SHEARON HARRIS NUCLEAR POWER PLANT
DOCKET NO. 50-400/LICENSE NO. NPF-63
REQUEST FOR LICENSE AMENDMENT

TECHNICAL SPECIFICATION PAGES

FIGURE 3.4-2

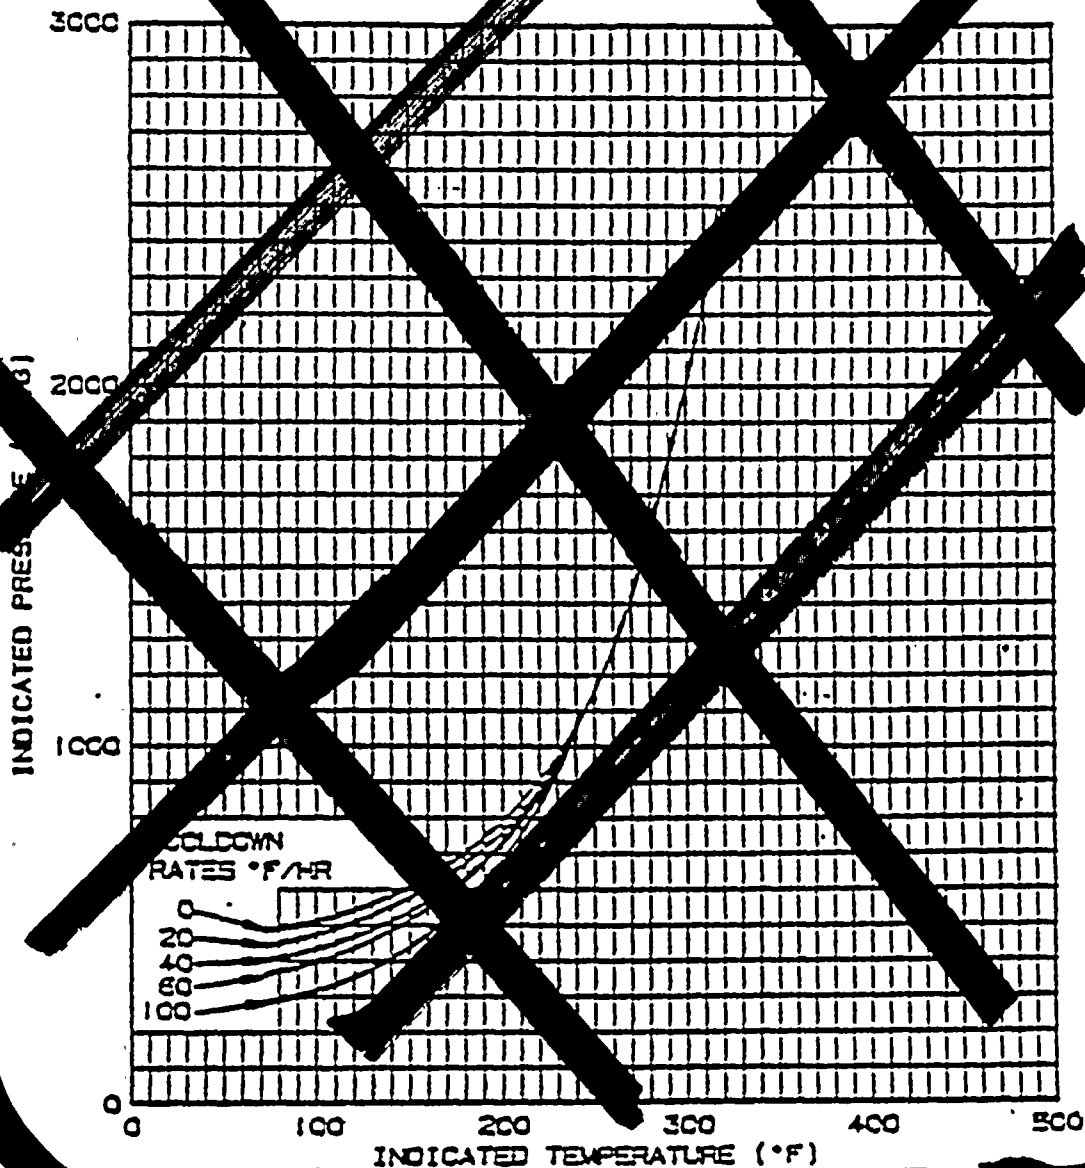
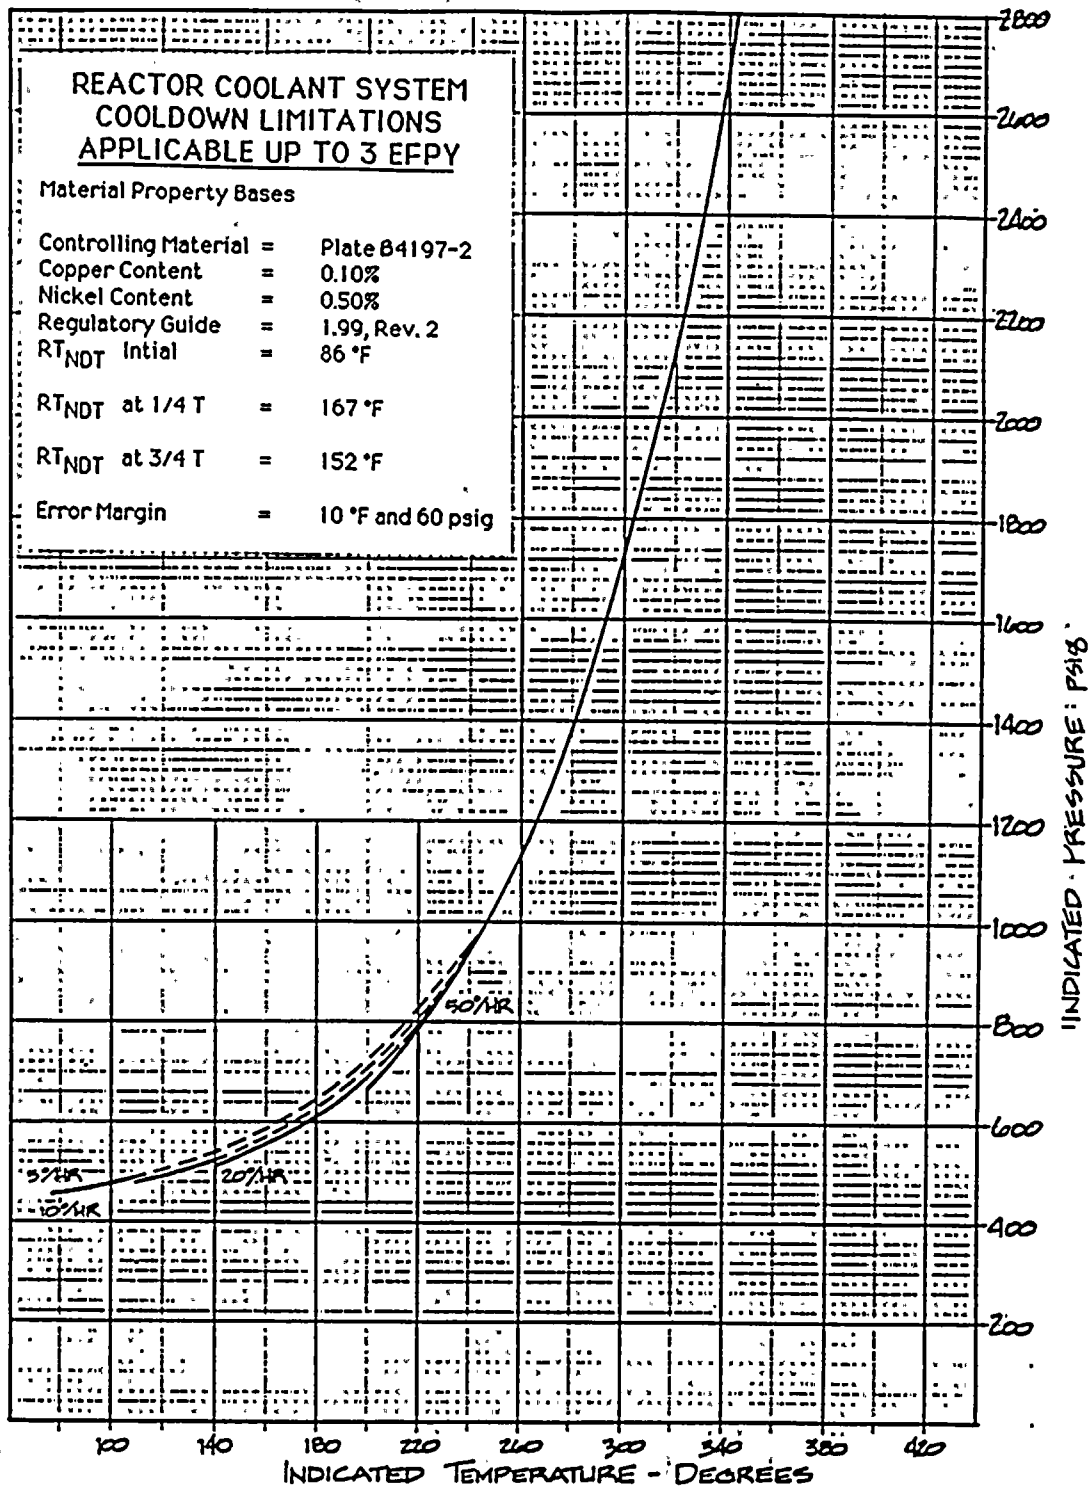
REPLACE WITH ATTACHED INSERT

CONTROLLING MATERIAL : PLAIN METAL
COPPER CONTENT : 0.10%
PHOSPHORUS CONTENT : 0.005%
NOT INITIAL : 50°F
NOT AFTER 4 EFPY : 1/4T, 15%
3/4T, 13%

CURVE APPLICABLE FOR COOLDOWN RATES UP TO 100°F/HR FOR
THE SERVICE PERIOD UP TO 4 EFPY AND CONTAINS MARGINS
OF 10% AND 50 PSIG FOR POSSIBLE INSTRUMENT ERRORS.

FIGURE 3.4-3

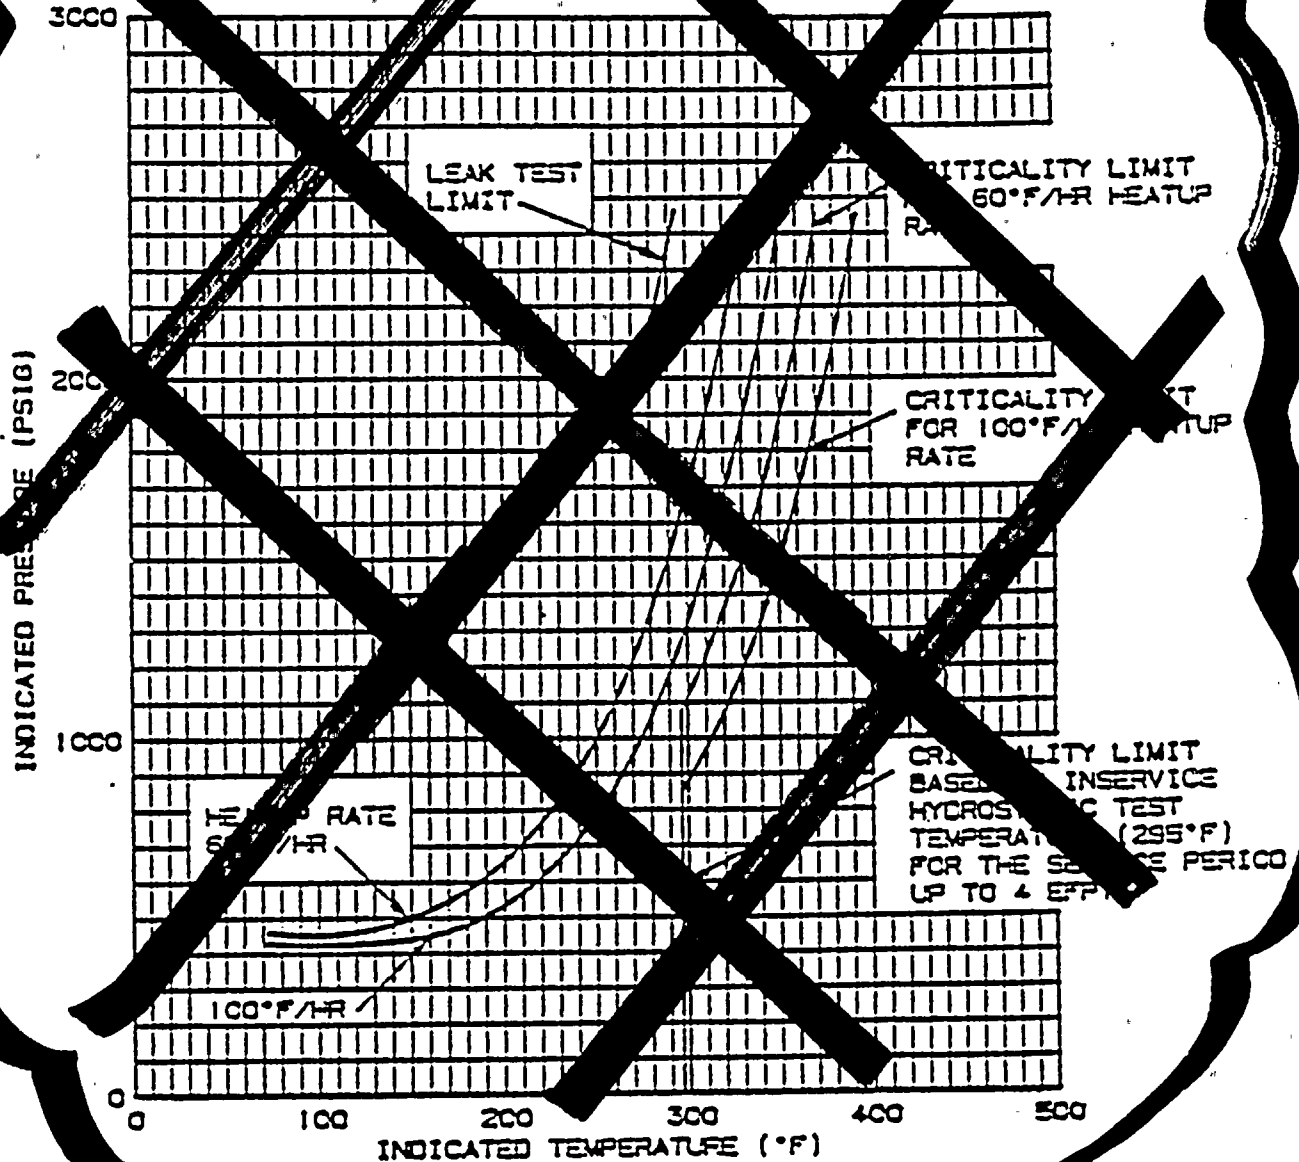
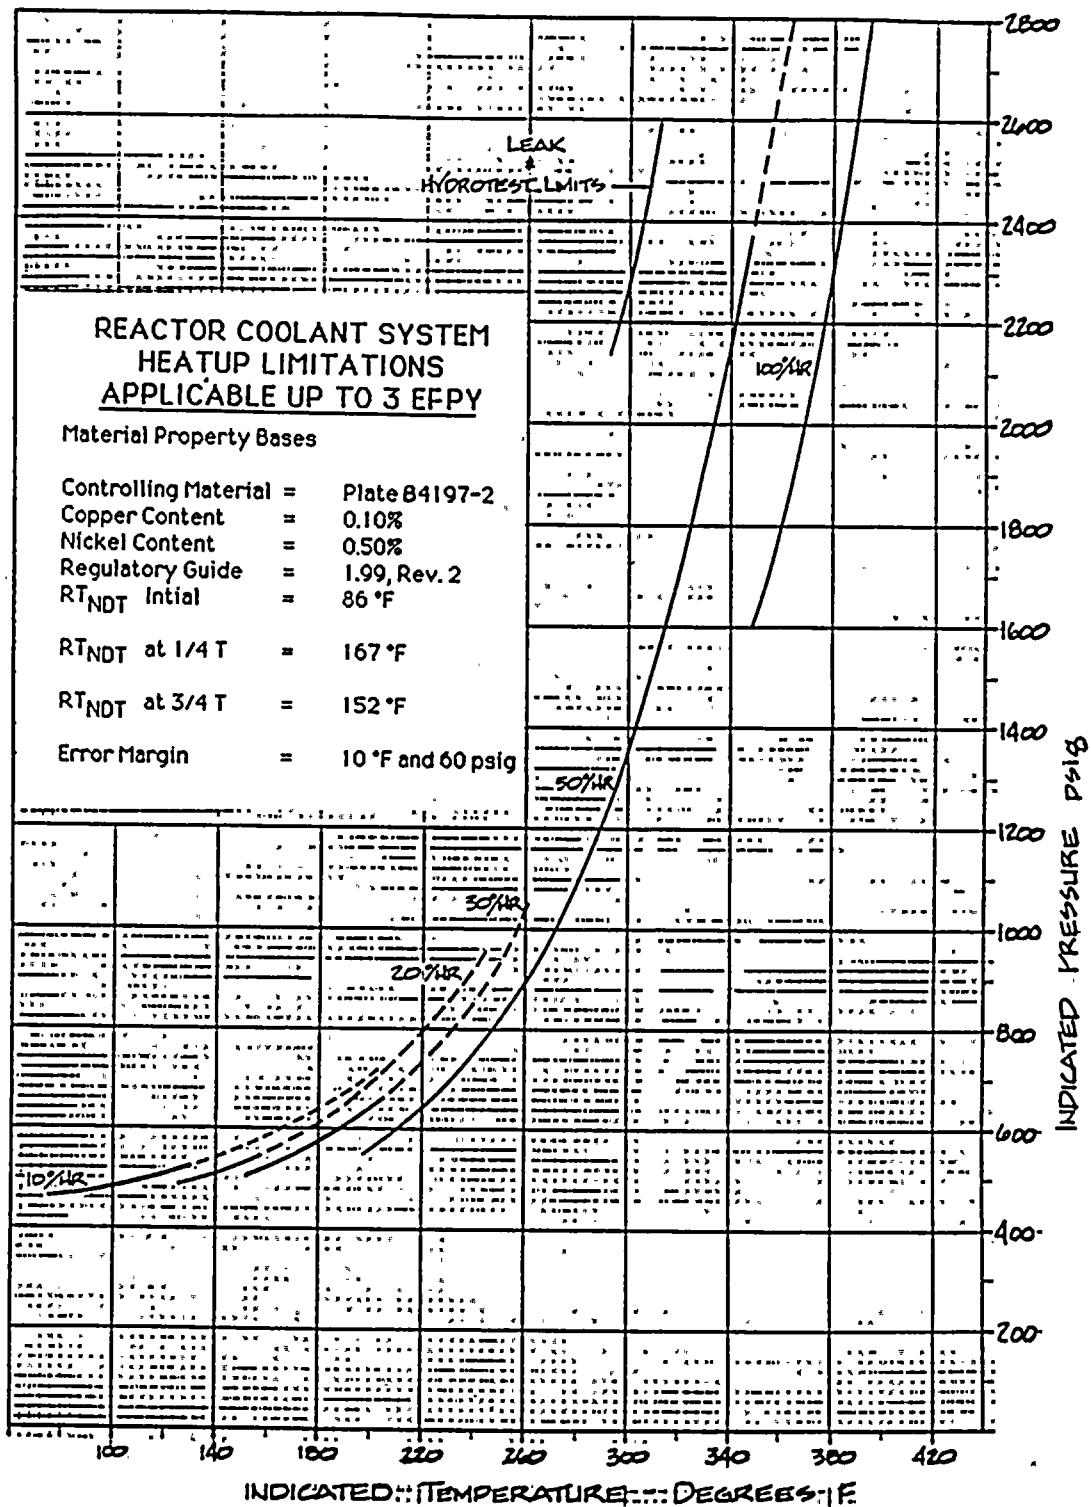
REPLACE WITH ATTACHED INSERT

CONTROLLING MATERIAL: PLATE METAL
 COPPER CONTENT: 0.10 WT%
 PHOSPHORUS CONTENT: 0.006 WT%
 RT NOT INITIAL: 1/2
 RT NOT AFTER 4 EPY: 3/4

CURVE APPLICABLE FOR HEATUP RATE UP TO 100°F/HR FOR
 SERVICE PERIOD UP TO 4 EPY. CONTAINS MARGINS
 OF 10°F AND 60 PSIG FOR POSSIBLE MEASUREMENT ERRORS

FIGURE 3.4-4

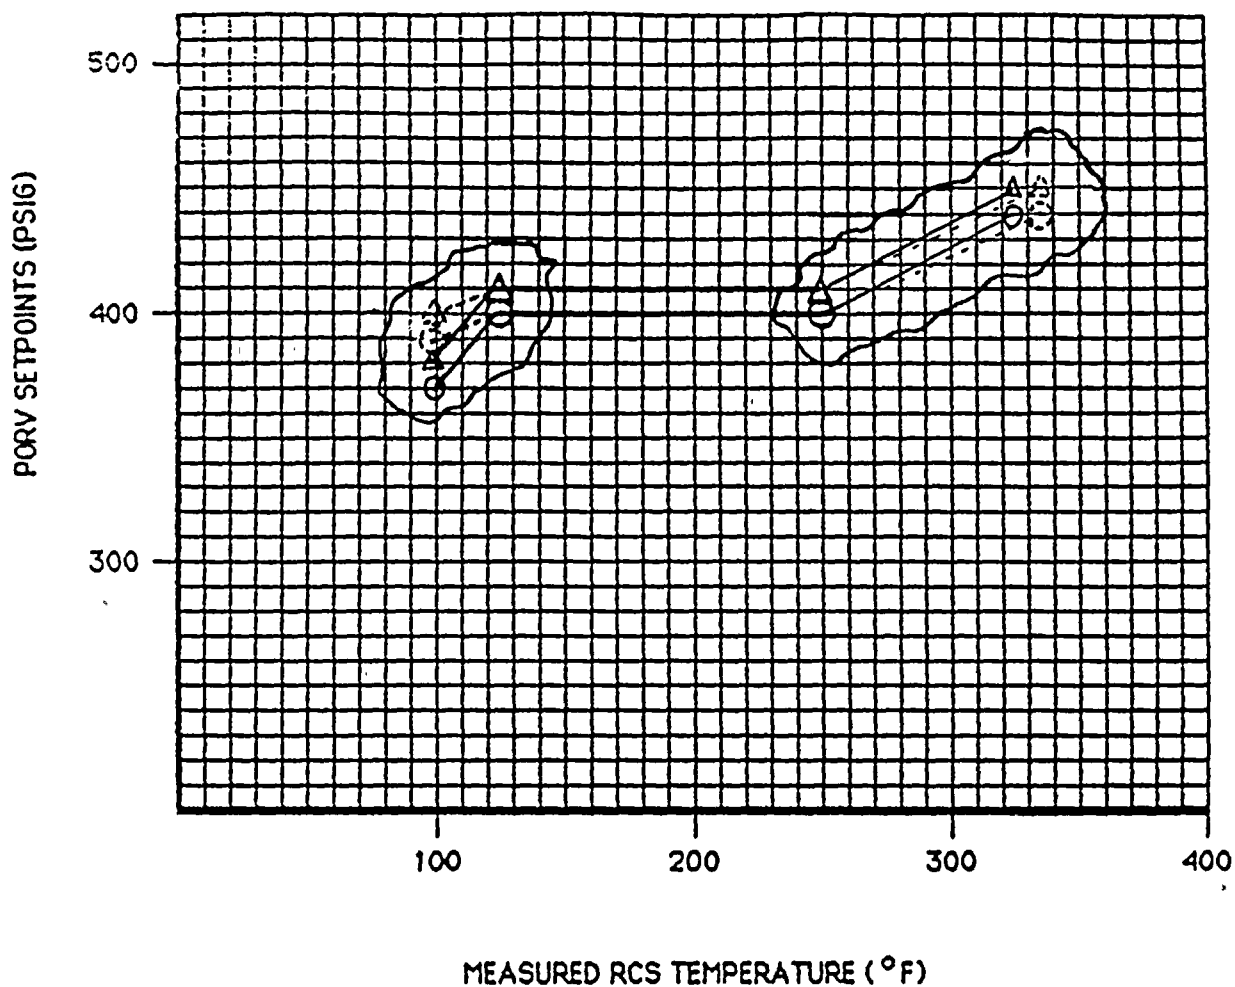
RCS TEMP OF	LOW PORV * PSIG ○	HIGH PORV * PSIG △
< 100	390 370	400 380
125	400	410
250	400	410
300	400 427	425 437
335 325	440	450

* VALUES BASED ON ³EFPPY REACTOR VESSEL DATA AND
CONTAINS MARGINS OF ⁻¹⁶ -16°F AND +60 PSIG FOR POSSIBLE
INSTRUMENT ERROR

FIGURE B 3/4.4-1

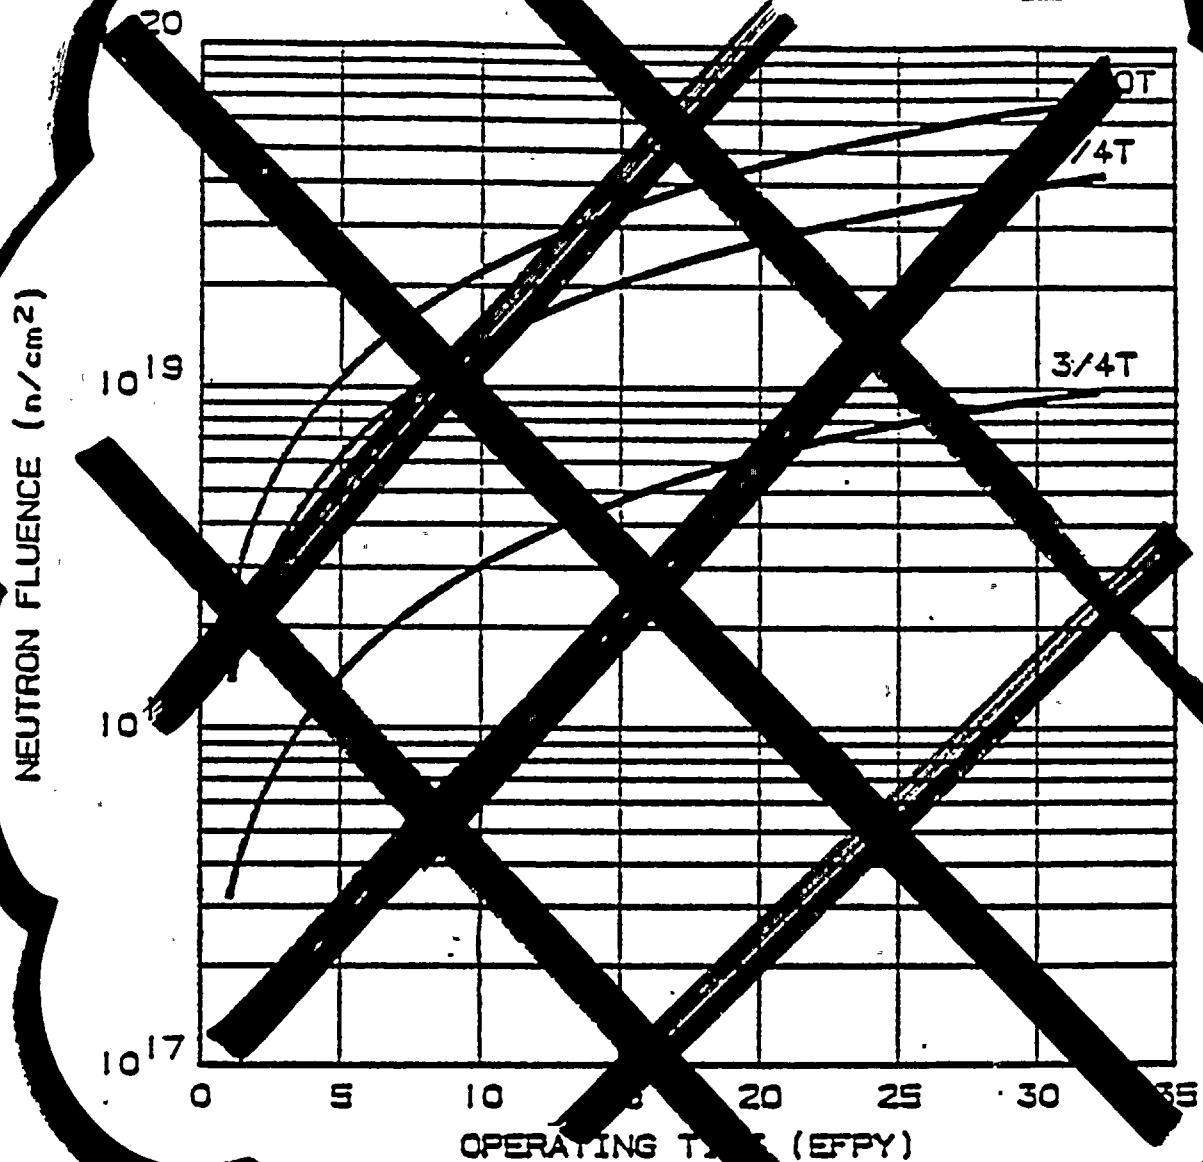
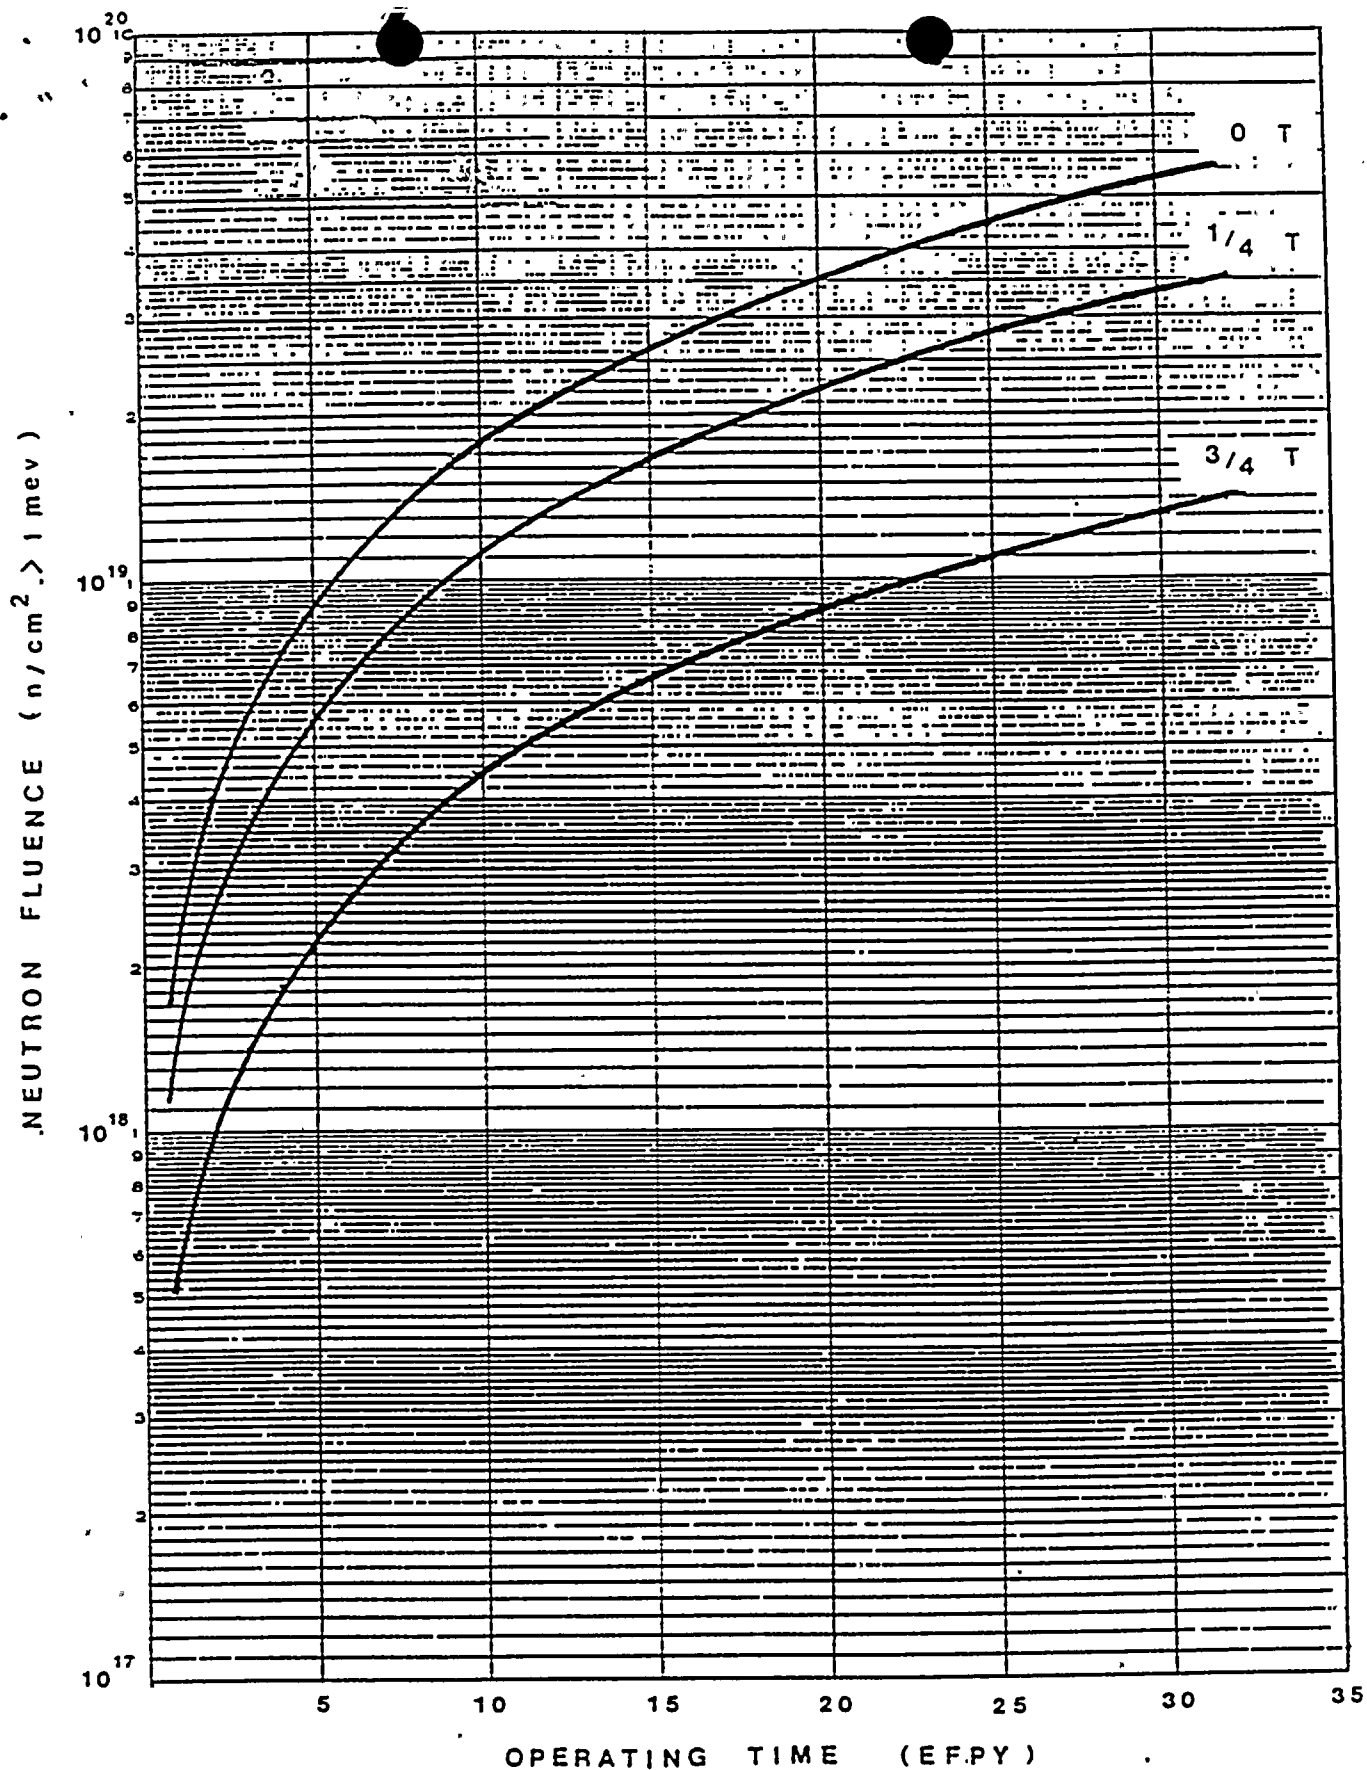
REPLACE WITH ATTACHED INSERT
